Bosch Telecom, Inc
1125 E. Collins Blvd.
Richardson, Tx 750816

Subject: Question ITU-R 119/9

PRELIMINARY DRAFT REVISION OF ITU-R RECOMMENDATION F. 1191,
“BANDWIDTH AND UNWANTED EMISSIONS OF DIGITAL RADIO-RELAY
SYSTEMS”

FIGURE 1
Unwanted emission attenuation objectives and
bandwidth definitions of DRRS

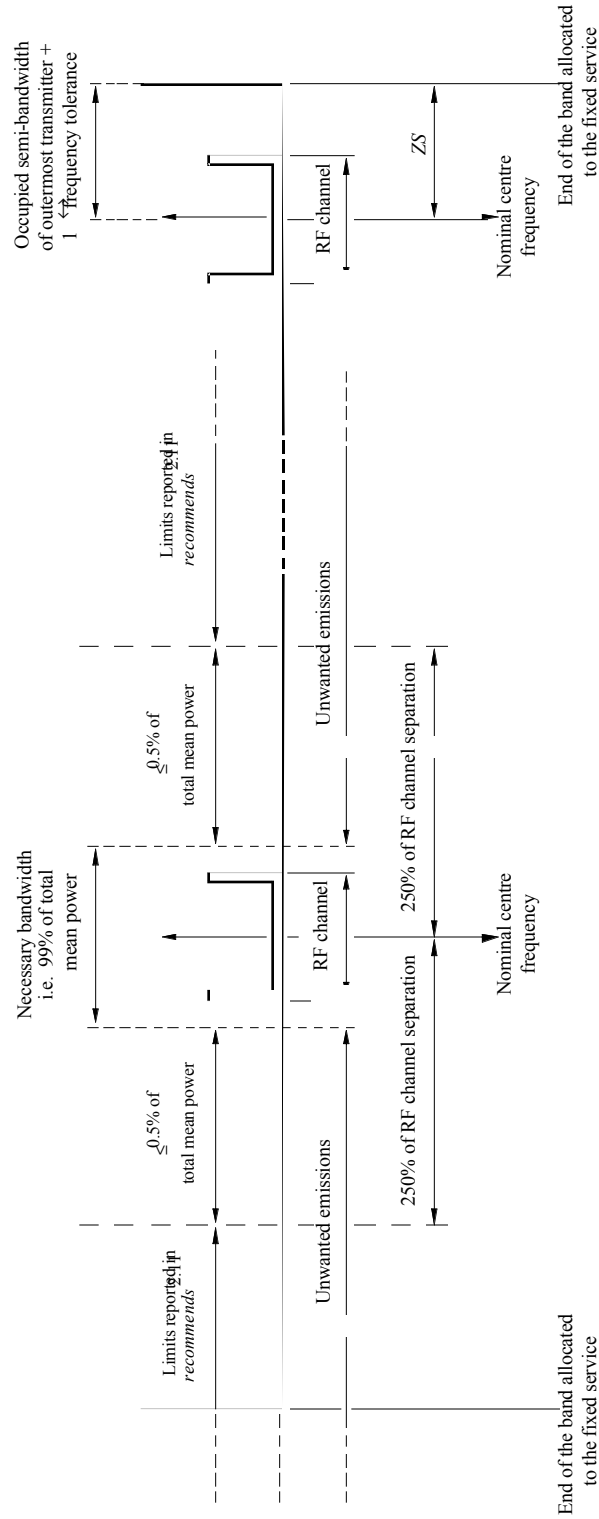
The distance ZS noted in Figure 1 is set so that the nominal center frequency, F_c , of the intended emission is within the assigned band. The distance ZS is normally at least half the necessary bandwidth plus the frequency tolerance of the transmitter.

The center frequency of an intentional emissions should be determined as the center frequency of the occupied bandwidth frequencies rather than using parameters related to the 3 dB bandwidth of the amplifier.

Figure 3, Example unwanted emissions mask typically used for a channelized band and a high power transmitter operated near the assigned band edge. (30 MHz Necessary Bandwidth, 15 dBW Mean Power, 27515.28 MHz Center Frequency, any 1 MHz resolution).

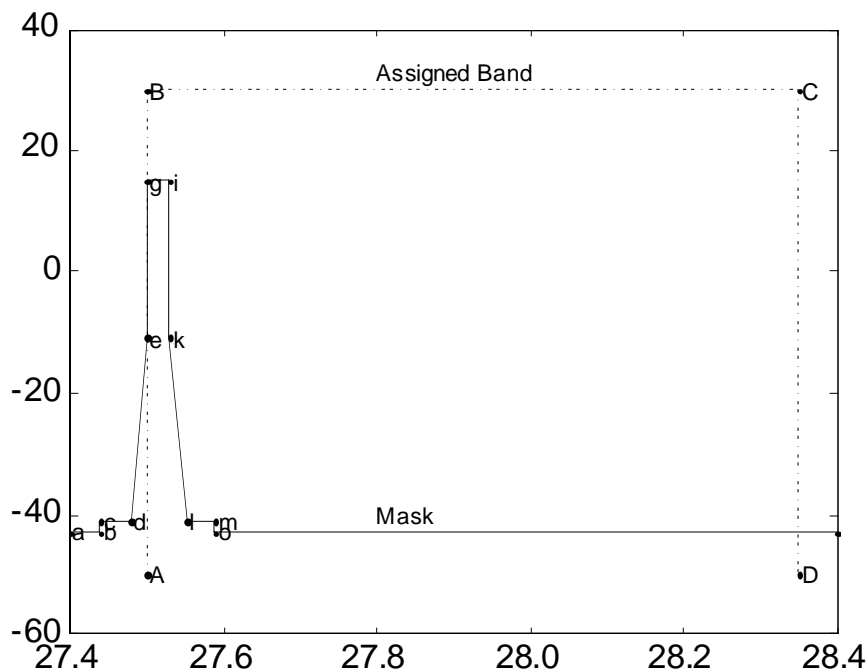
The example of Figure 3 shows that unwanted emissions requirements also apply inside the assigned band.⁴ While the portion of the mask outside the assigned band is an appropriate requirement, the portion of the mask inside the assigned band is unnecessary because the unwanted emissions will only produce self-interference to the licensee's system.

Figure 4, Example emissions mask for a channelized band and a low power transmitter and operating near an assigned band edge. (30 MHz Necessary Bandwidth, 0 dBW Mean Power, 27515.28 MHz Center frequency, any 1 MHz resolution).

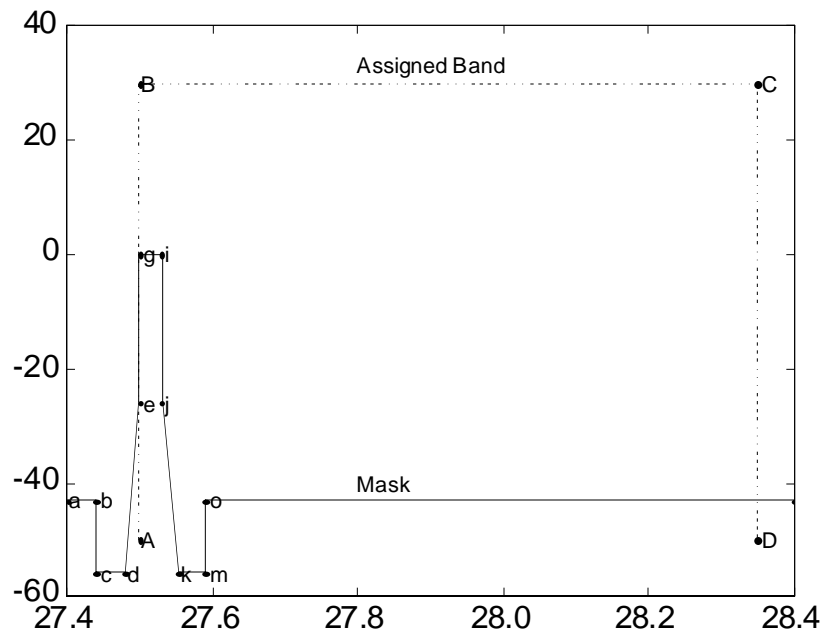
Figure 4 shows a mask that is typically used for a low power transmitter in a channelized band. The mask is calculated for a 30 MHz necessary bandwidth (line *gi*) and a mean power of 0 dBW. The center frequency, F_c (line *gi* midpoint), has been selected such that the lower portion of the mask is outside an assigned band (line *BC*). The upper portion of the mask falls inside an assigned band. Lines *ab* and *op* represent spurious emission limits. Lines *cd* and *km* represent the portion of the OOB mask that is limited by an attenuation of 56 dBc and is also below the level allowed for spurious emissions. Note that in the out-of-band region, attenuation is below the spurious limits. Transmitters operating at reduced power due to automatic power control exaggerate this example. Note also the requirement for unwanted emission control within the assigned band. This mask is unnecessarily restrictive for block allocated bands.
